**ZEE Systems, Inc.**

***SERVICE LETTER 47-003-4***

- 1.0 EFFECTIVITY: All SZ47-003-(X) Blower Assemblies.
- 2.0 PURPOSE: To provide an alternate kit for the replacement of the Blower Motor in the Blower Assembly.

FIG. 1

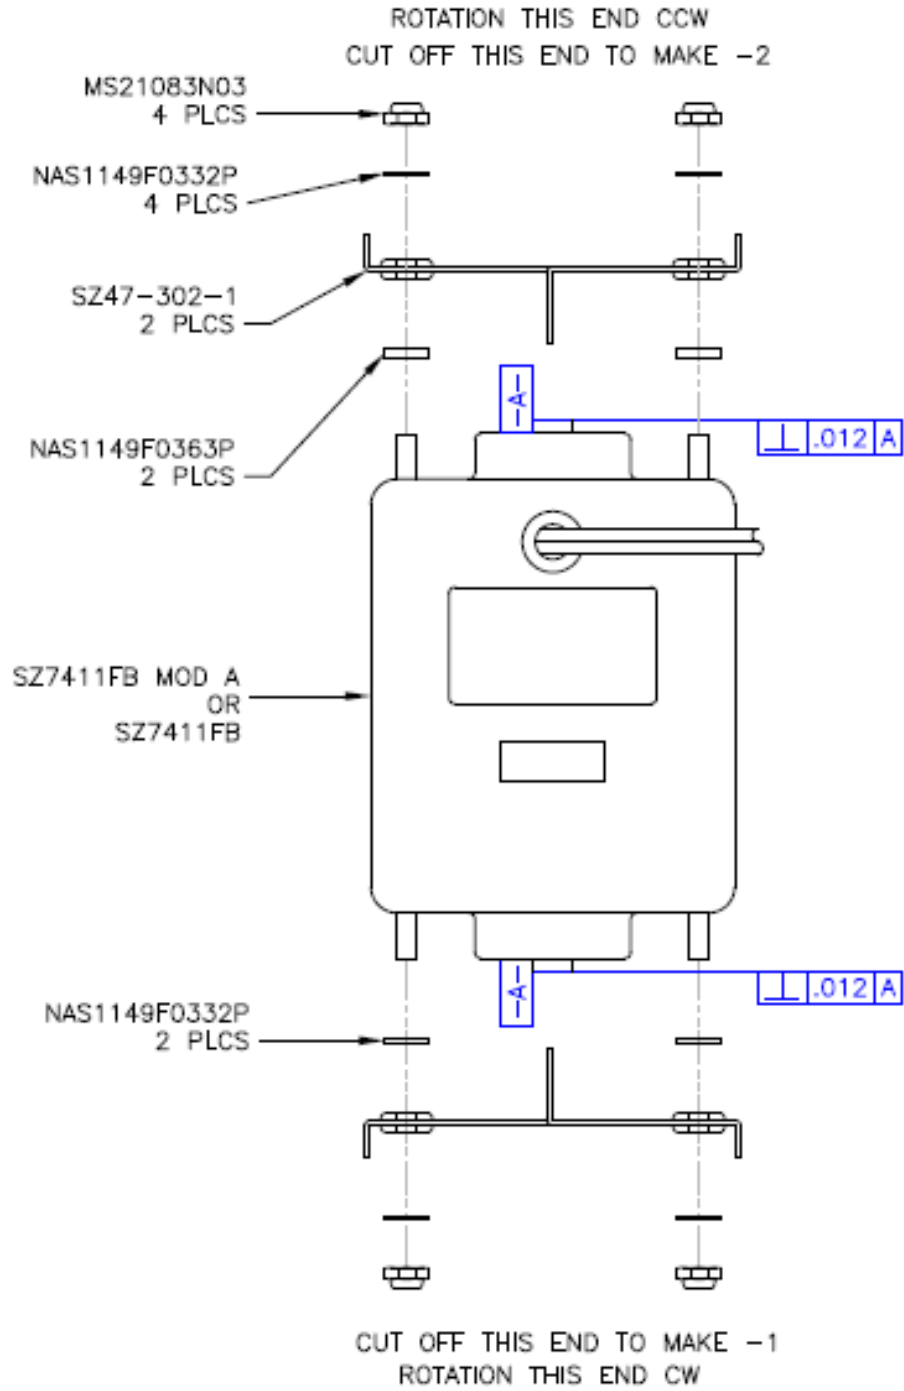
- 9.4 After the opposite shaft has been removed place 1 each Motor Support SZ47-302-1 on each end of the motor. Secure as shown on parts break down, see FIG. 1.

**FIG. 2**

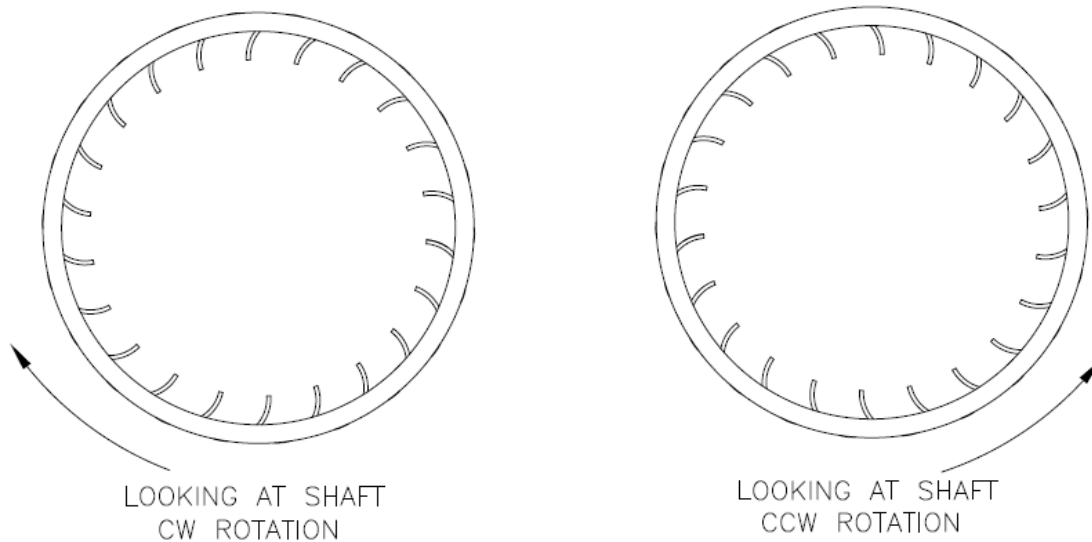
- 9.5 The 16-2527 Blower Wheel rotation must match the rotation of the shaft. See FIG. 2. Push the Blower Wheel onto the shaft until you have the same spacing as the old wheel. Fit the motor and wheel into the Lower Housing (17-2642). Adjust the position of the wheel on the shaft so it does not touch the housing on either side. Adjust the spacing of the wheel on the shaft as necessary. When the proper spacing is achieved attach the 916-901 Clip on the Blower Wheel.

FIG. 3

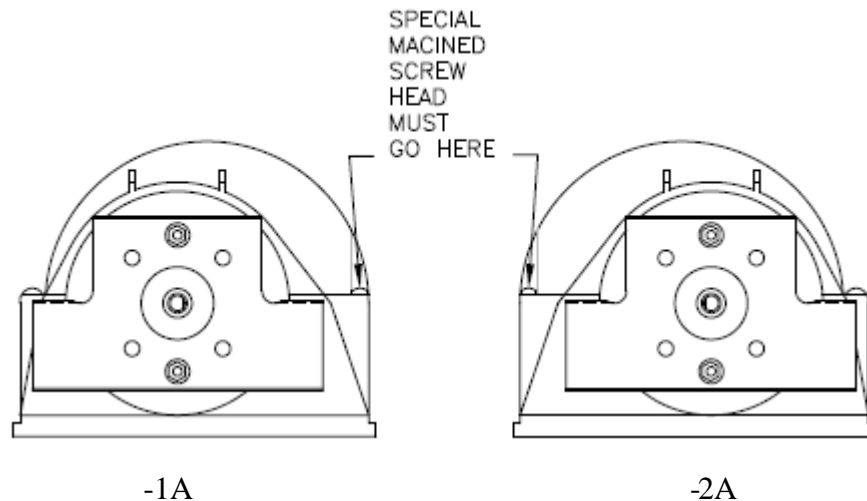
- 9.0 INSTRUCTIONS:
- 9.1 Remove the 8 Trac screws that hold the two blower housings together. Retain the screws for reassembly. Remove the Top Housing (17-2641). Note the spacing of the Blower Wheel in the Lower Housing (17-2642). Note that one of the screw heads has been machined down. Install in the same location, See FIG. 3.
